# Groundwater Application Review Summary Form

Application # G- 18500

TO: Water Rights Section Date 8/15/2017  
 FROM: Groundwater Section Dennis Orłowski  
Reviewer's Name  
 SUBJECT: Application G- 18500 Supersedes review of \_\_\_\_\_  
Date of Review(s)

**A. GENERAL INFORMATION:** Applicant's Name: Canby 170, LLC County: Clackamas

Water-Level Trends in Nearby Wells (Static Only)

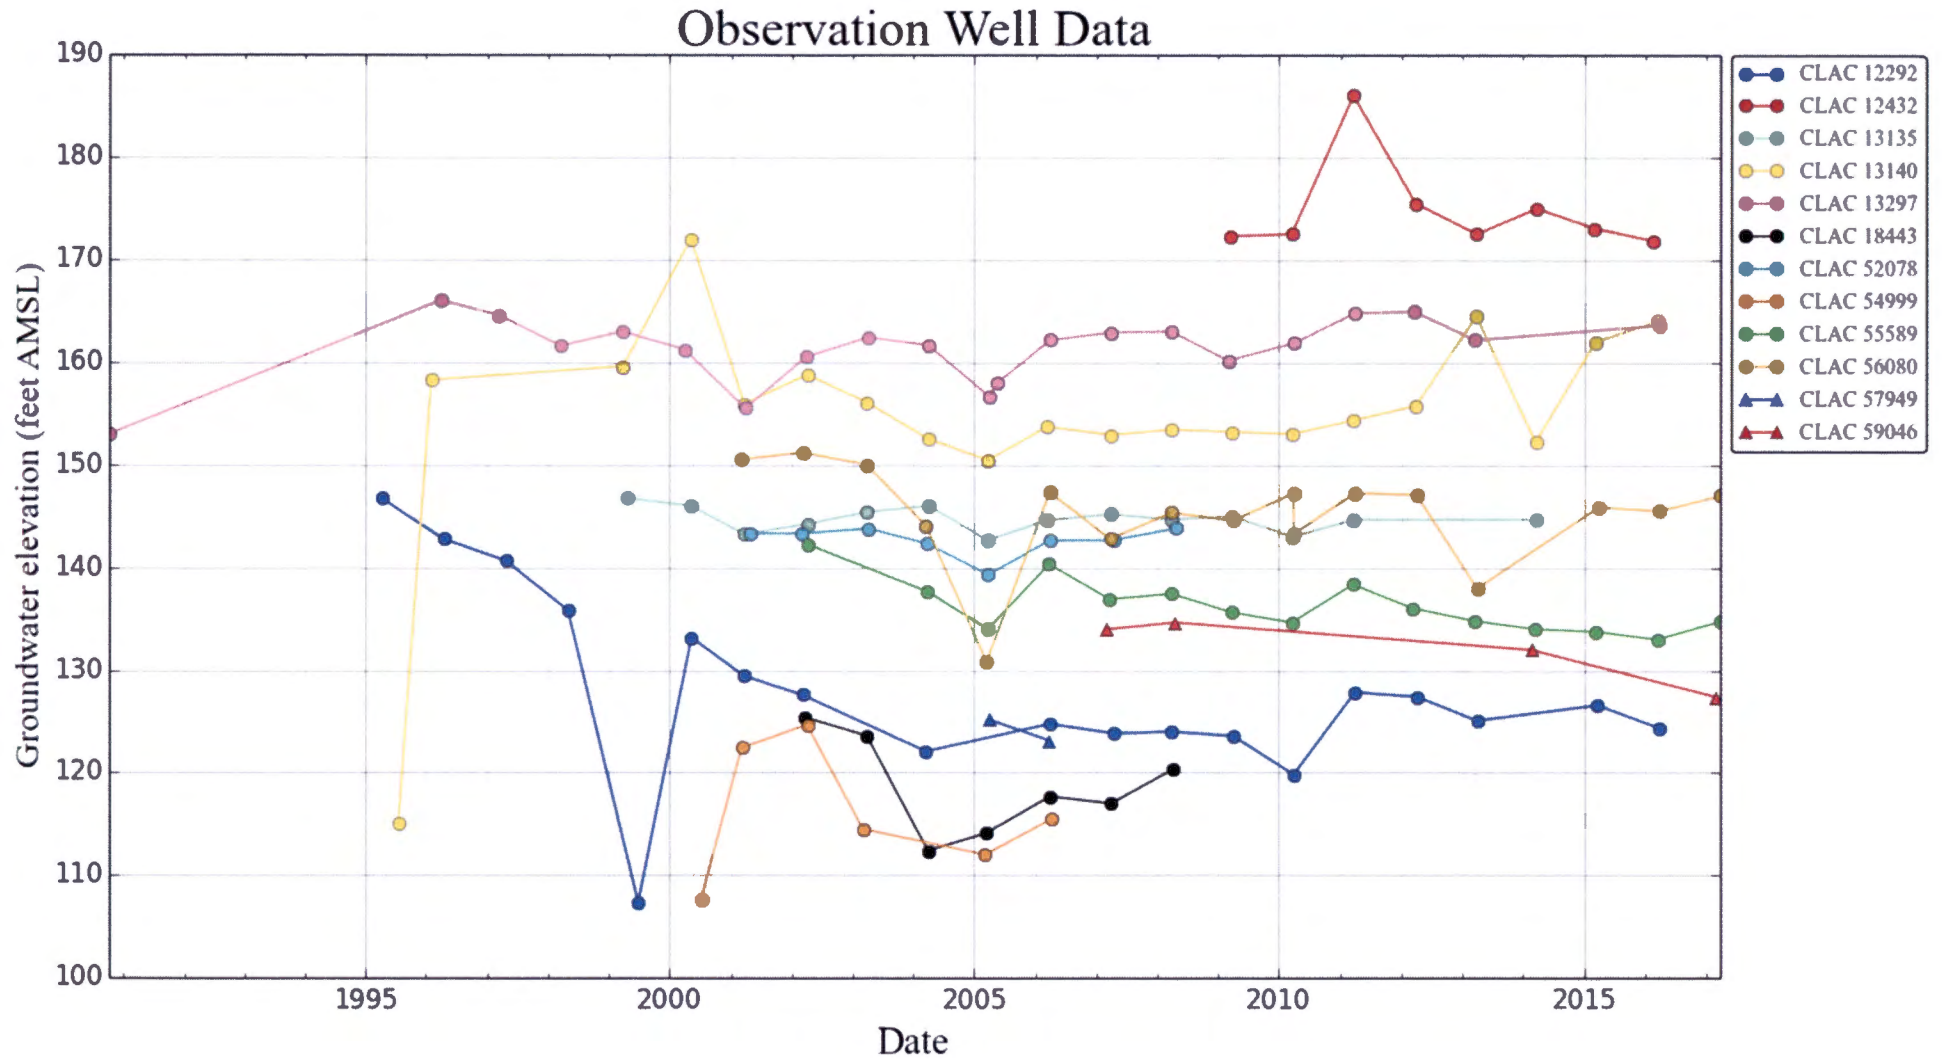
Groundwater elevations in the area range from about 140-180 ft msl (Gannett and Caldwell, 1998; Conlon and others, 2005). For about a ten year period ending in 2005-2006, several area wells exhibited declining trends on the order of ~20 feet (see attached hydrograph). However, since that time groundwater levels have been fairly stable. Not exhibited by the available data are seasonal pumping ranges, but experience in similar settings suggests the range can be fairly high, from ~20-40 ft, so seasonal pumping interference is a concern.

Hunt 2003 Stream Depletion Model Results

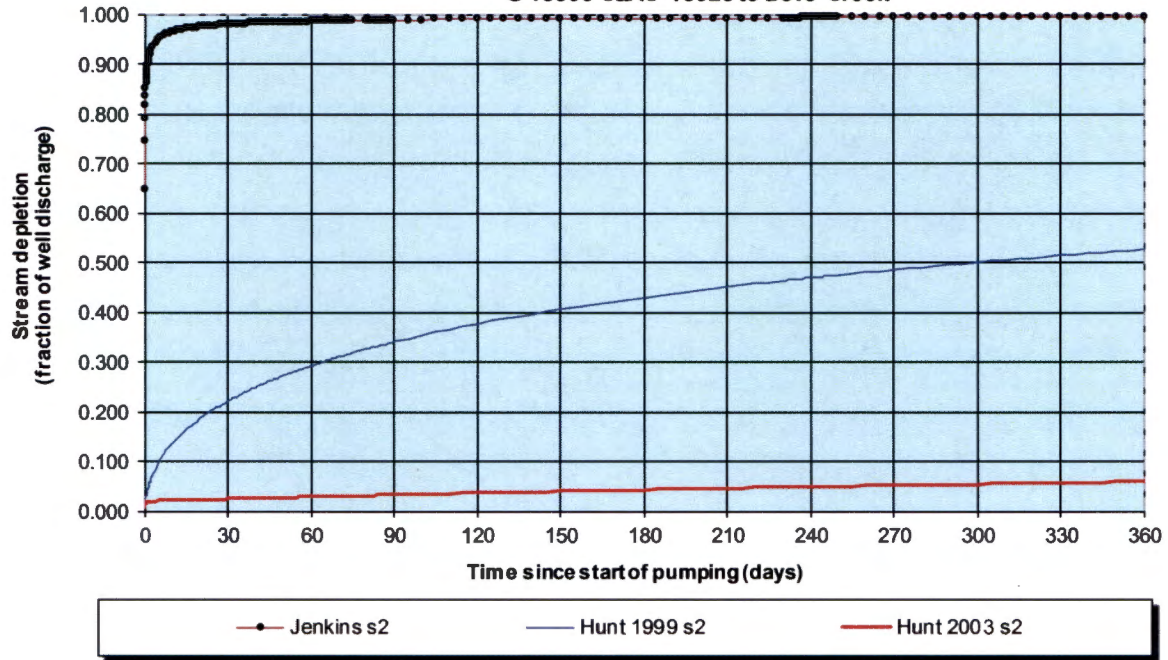
The Hunt 2003 analytical stream depletion model was used to estimate pumping interference at 30 days at SW1. Model results indicate that interference is expected to be less than 25% of the maximum allocated pumping rate at 30 days. The model was not applied to SW2 because it is within the same WAB and is several thousand feet farther away, and thus the estimated stream depletion would be significantly less than that estimated for SW1.
